**BOONE MEMORIAL HOSPITAL  
BOONE COUNTY, WEST VIRGINIA**

**BMH DANVILLE CLINIC – SHELL FIT OUT**

**ADDENDUM #1**

**THRASHER PROJECT #T60-11089**

**1 SECOND FLOOR LIFE SAFETY PLAN**  
G1.01 3/16" = 1'-0"

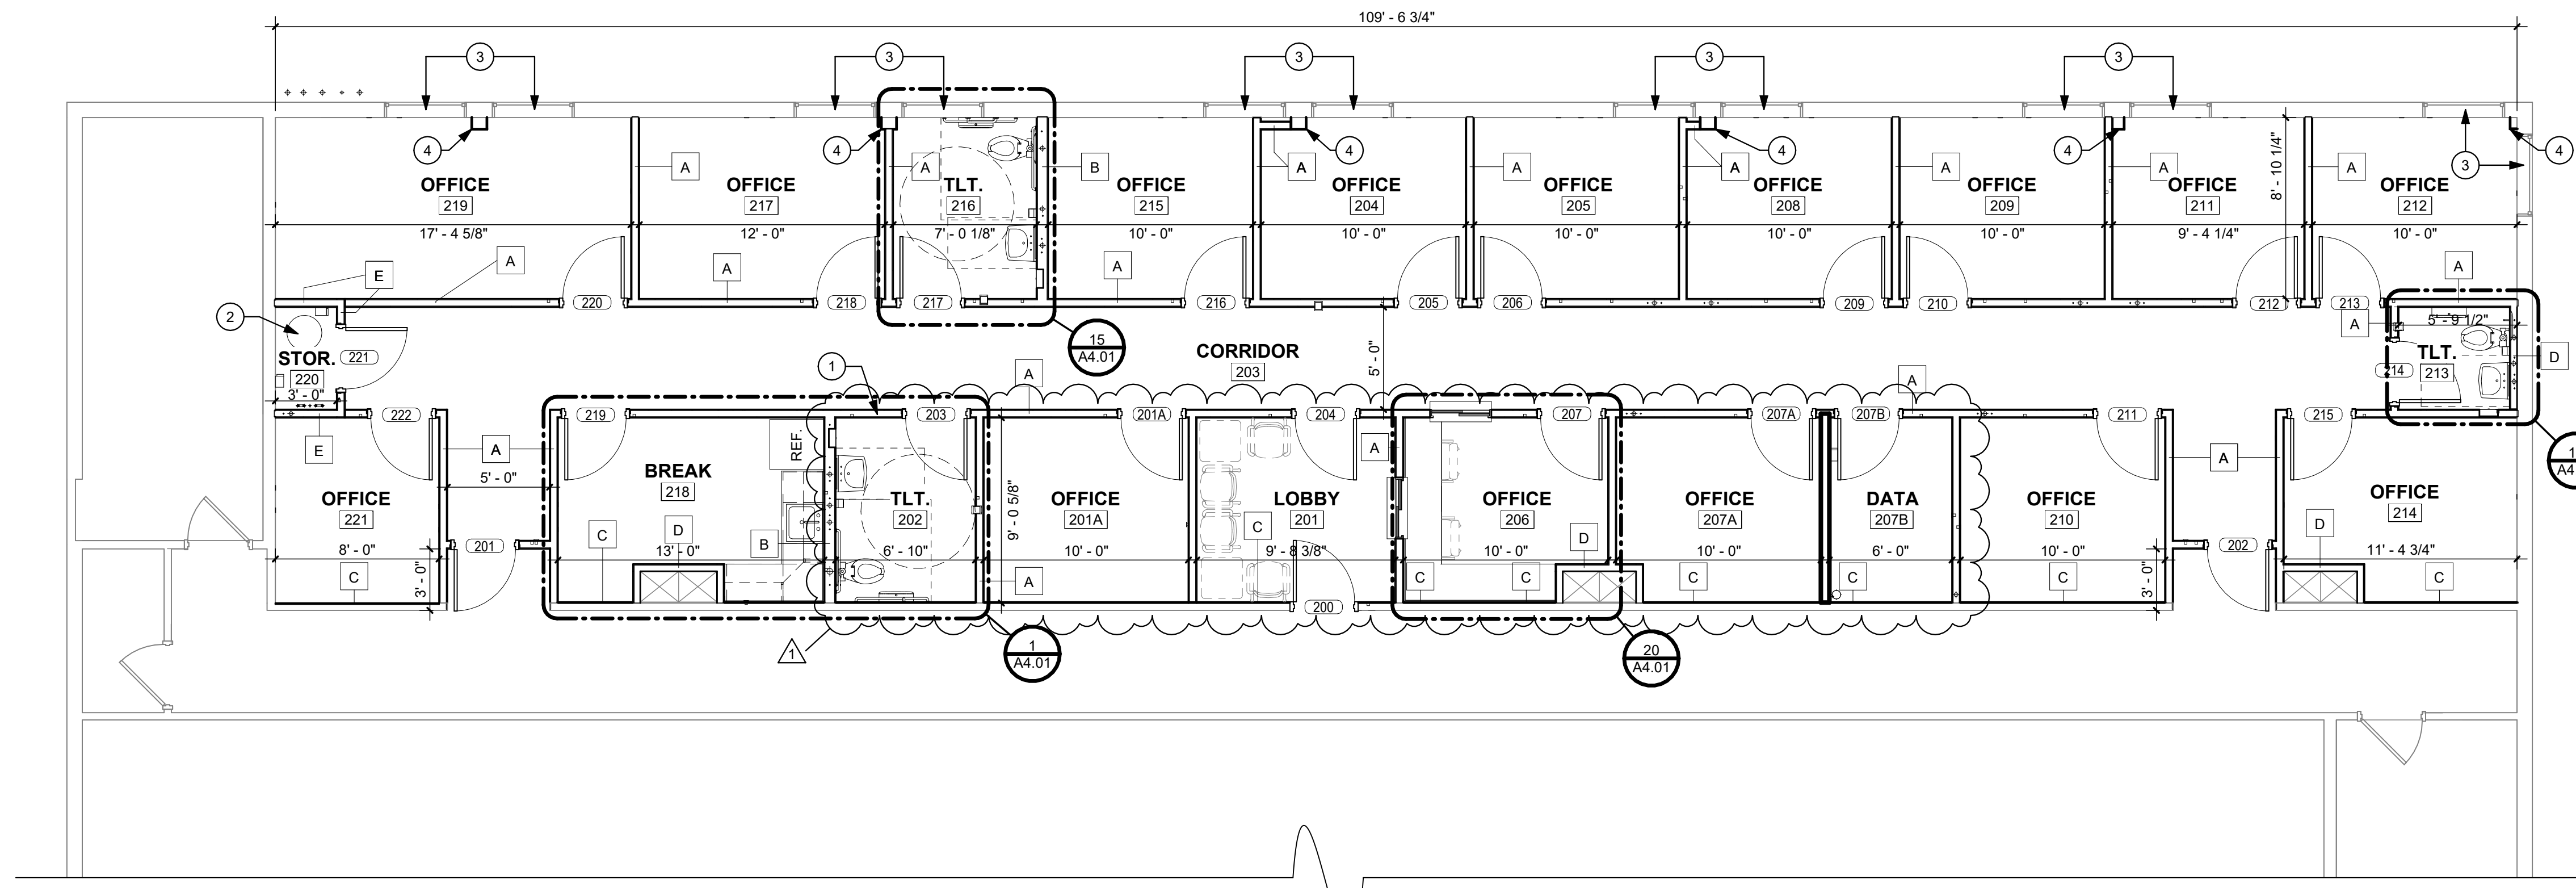
34. There is a spec for Fire Extinguisher Cabinets but on Sheet G1.01 it appears there are only Wall Mounted Fire Extinguishers. Please confirm there are no FECs.

Fire extinguisher cabinets shall be provided.

**A4.01**

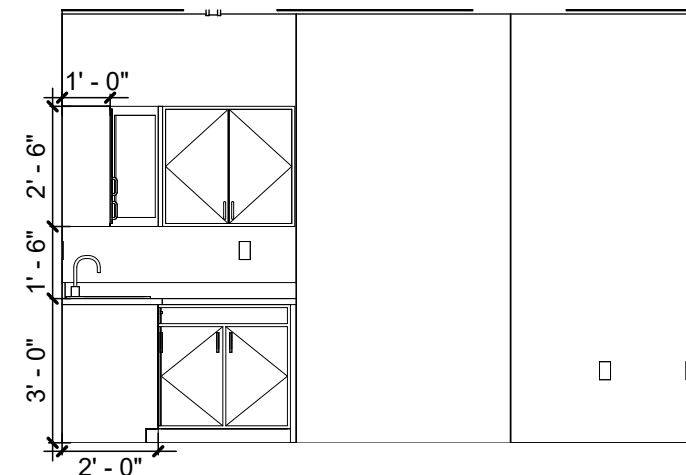
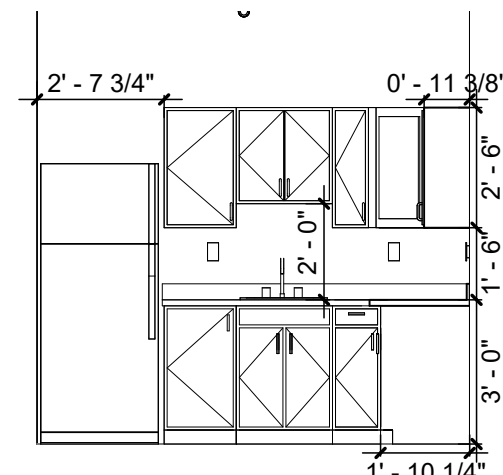
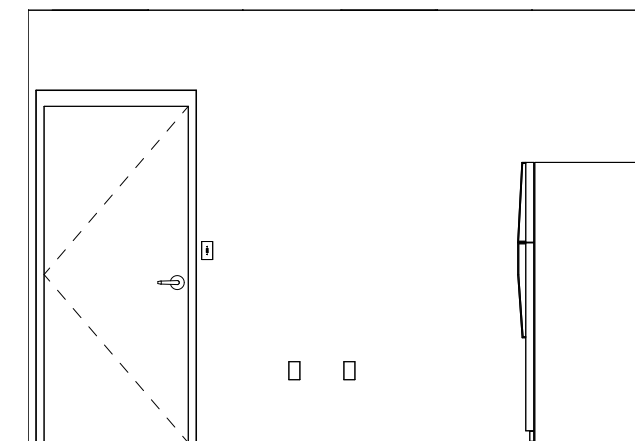
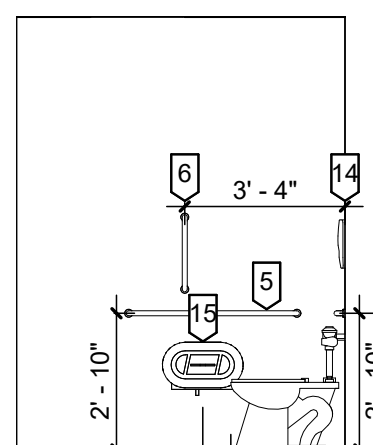
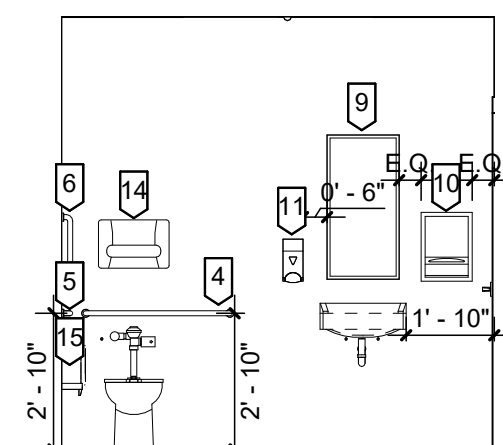
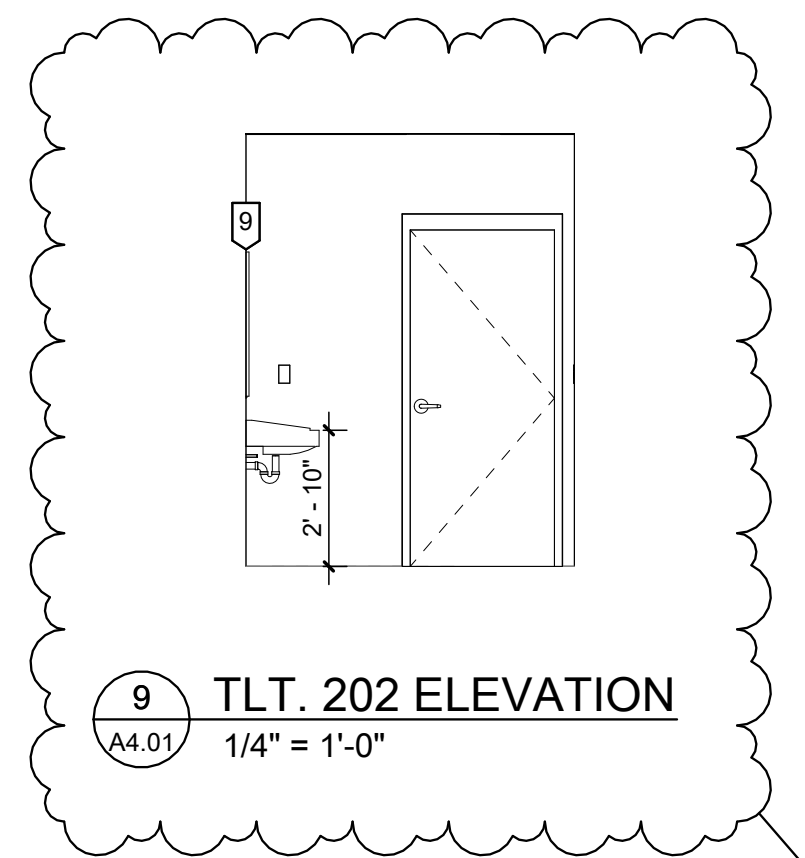
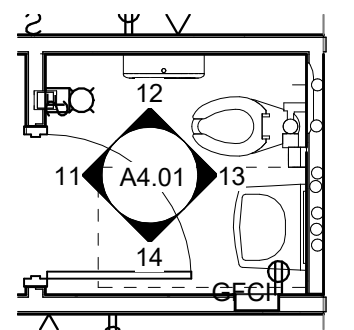
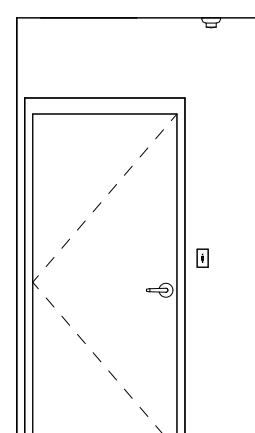
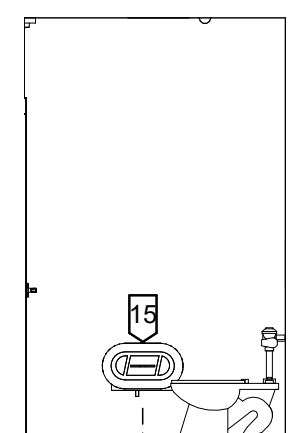
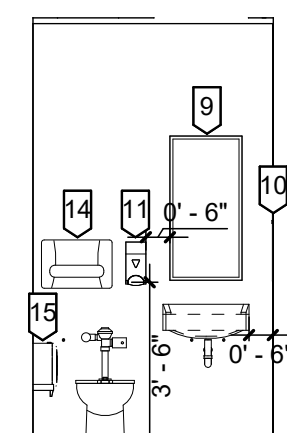
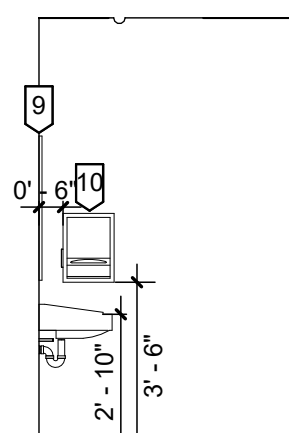
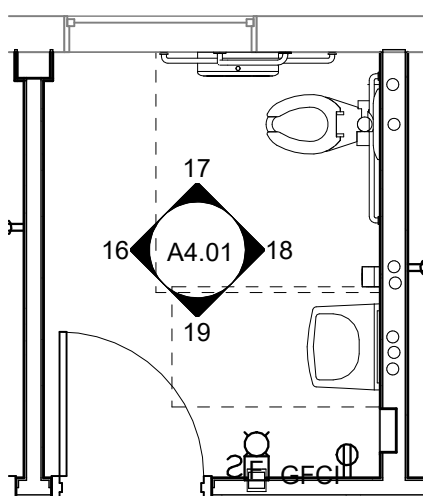
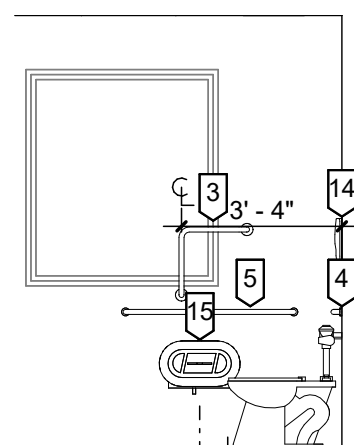
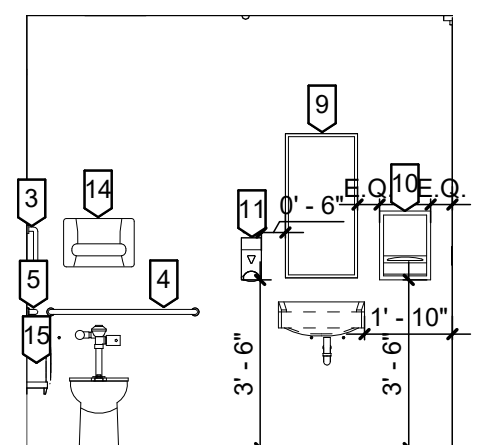
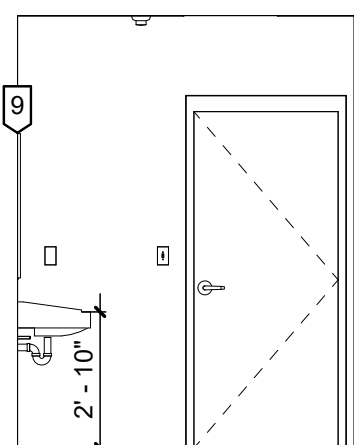
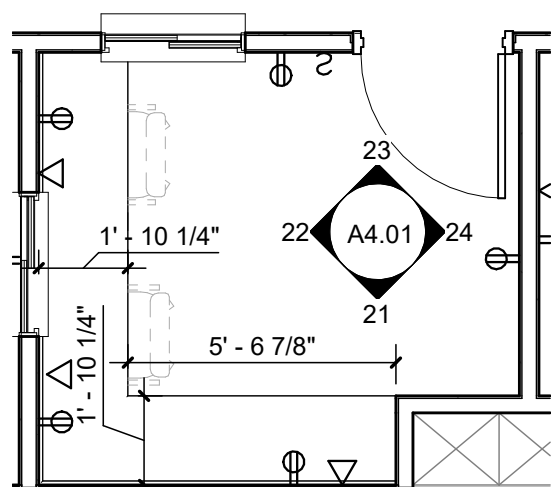
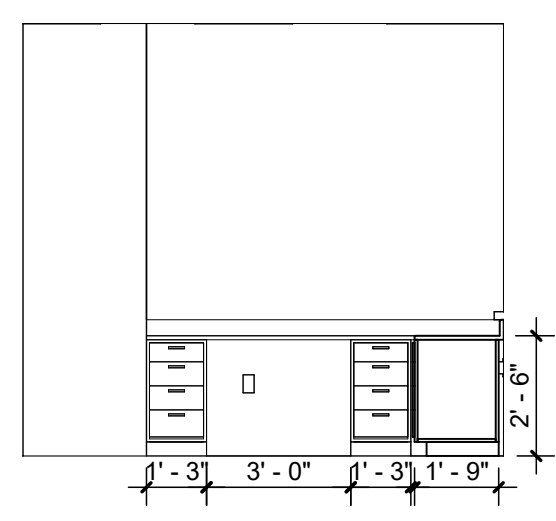
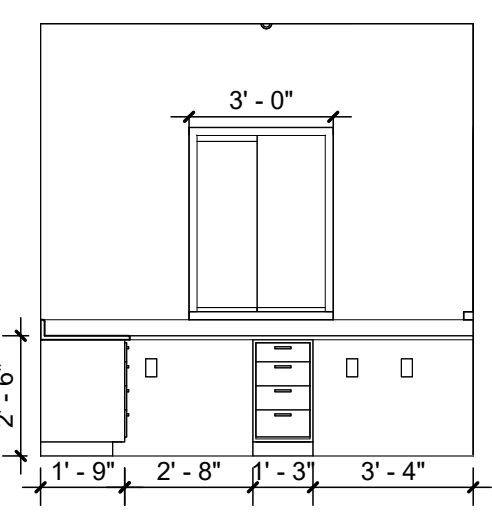
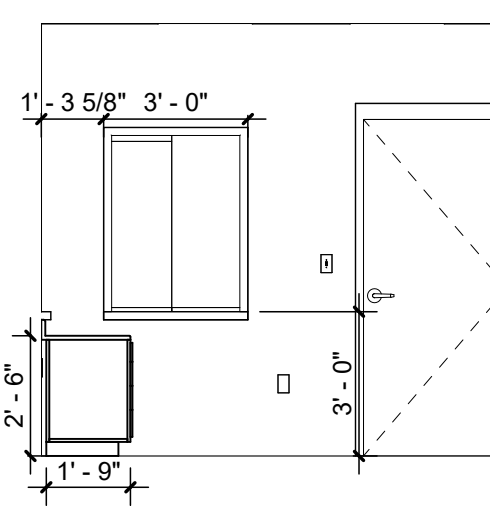
31. On Sheet A4.01, please confirm that Tag #: 1, 2, 7, 8, 12 & 13 are not used.

Accessories tagged #1,2,7,8,12, and 13 are not used in the project.
